Flight Procedures Cover Page	Task Action: FLIGHT CHECK	Task Type: SID	Estimated Chart Date: 12/26/2024	APWS Task ID: CB11A9E2DB7243D981B8C74474A395CB	APWS Project ID: 390916A4584F4D93AE5FA92B3B779EF8	
Procedure: SID DALLAS FOUR DALLAS TX KDAL		Enroute: YES	Specialist: Keefer, John		Agreement Number:	
Airport ID: KDAL			Airport City: DALLAS		State: TX	
Facility ID:	Facility Type:	Flight Inspection Remai New FC Slot	rk Type:

DALLAS FOUR DEPARTURE

DALLAS FOUR DEPARTURE (DALL4.TTT) FIG

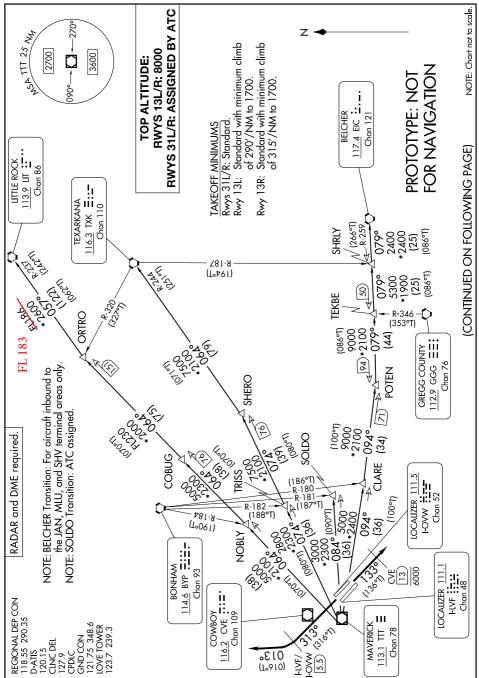
LITTLE ROCK VORTAC MOVED 8 MILES NORTH.

8260-1 WAIVER FOR VECTORING BELOW THE MVA.

LITTLE ROCK TRANSITION (DALL4.LIT): From over TTT VOR/DME on TTT R-064 to ORTRO, then on LIT R-237 to LIT VORTAC.
